RE: NOI Peer Review
263 New Boston Road / Parcel ID: 455-01144-263
Sturbridge, Massachusetts
DEP file no. 300-1166

Ecosystem Solutions, Inc. has finalized the NOI peer review for the above-referenced property (Property).

- Plans titled "CONSERVATION COMMISSION PLAN", sheets 1-2, by DC Engineering & Survey, Inc., stamped by Jason D. Dubois P.E. No. 48724, and dated March 31, 2023, with a final revision date of March 31, 2023 and at a scale of 1"=40'.
- NOI submitted on behalf of Kenneth LeBlanc including: Notice of Intent forms and attachments, Sturbridge NOI forms including abutters list and notification letter, General Project Description, Data forms and Site Pictures.

FIGURE 1
 Georeferenced Plan on 2021 aerial orthophoto, w/ notes added
 Yellow shaded areas are where flag changes are proposed.

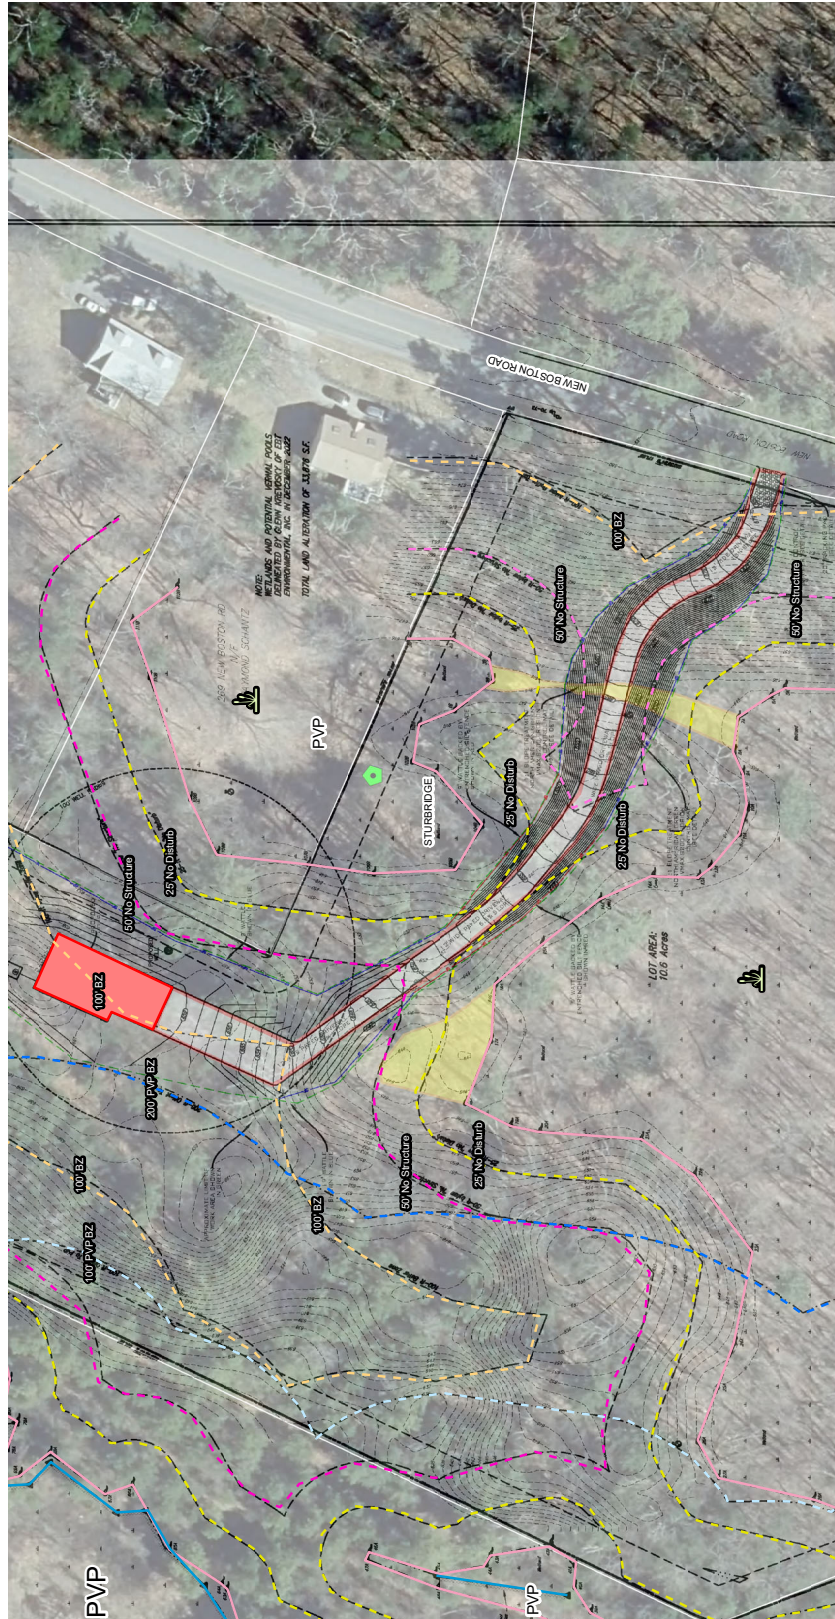
1. A site inspection was conducted on Wednesday, August 16, 2023. Sturbridge had a rainstorm the night before with a total of 0.92 inches of rain. It is our opinion that wetlands on-site are somewhat more extensive than current flagging displays. Furthermore, the B-series wetland connects to the A-series wetland through a narrow saddle over which the driveway is proposed. ***This means that the B-series wetland is actually a BVW.*** Pink flags were placed in three areas where we recommend revisions, as follows:

2. Flags SCC WET 9D-1 and SCC WET 9D-2 were placed near the D-series flags to round out a corner that had not been included by EBT just beyond the western Property boundary. This area was expanded due to signs of hydrology, water-stained leaves and drainage patterns, and hydrophytic herbaceous vegetation.

3. Flags SCC WET 16A-1 through SCC WET 16A-6 were placed between flags 16A and 18A. They extend around a small depression with water-stained leaves, soil with a reduced matrix and hydrophytic herbaceous vegetation, bringing the vegetated wetland further north approximately thirty (30) feet. This small depression is almost separated from the rest of the

4. Flags SCC WET 1 through 5 were placed between flags 7A and 3B. SCC WET 101 through 105 were placed between flags 8A and 2B. These flags travel through a small gulley and connect the A-series wetland to the B-series wetland. This area was somewhat difficult to evaluate. A small grove of white pine saplings (*Pinus strobus*) sits at the base of the slope where the driveway is proposed. Several soil samples were taken in this area. They showed a thin layer of topsoil above a layer of gravelly loamy sand that was four to six inches thick. Below this layer was a deep layer of organic soil reaching down nearly three feet in some areas. These soil conditions are in line with the definition of a histosol according to the US Army Corps of Engineers Regional Supplement to the Corps of Engineers Wetland Delineation Manual: Northcentral and Northeast Region. It is our opinion that gravel mining operations or erosion caused a buildup of sand and gravel in this area which has allowed white pine, a plant normally indicative of upland conditions, to grow in this area. The sand and gravel create more pore space in the soil and allow the roots of the pine tree to survive in soils that would otherwise be too wet. Regarding the white pine, which is *not* a hydrophytic/wetland plant, we believe that despite the heavy cover of this species, that the area still qualifies as wetland. White pine commonly grows in sandy, wet areas, and if allowed to grow larger, would exhibit hydromorphic adaptations to life in wet conditions such as buttressed trunks, at a minimum.

At this time, we recommend revising the wetland delineation to reflect the adjustments ESI made in the field. I recommend that the Commission discuss the ramifications of the possibility of a wetland (BVW) crossing under the Sturbridge Wetlands Protection Bylaw and Regulations, using my comments 1 through 6 above as a guide.
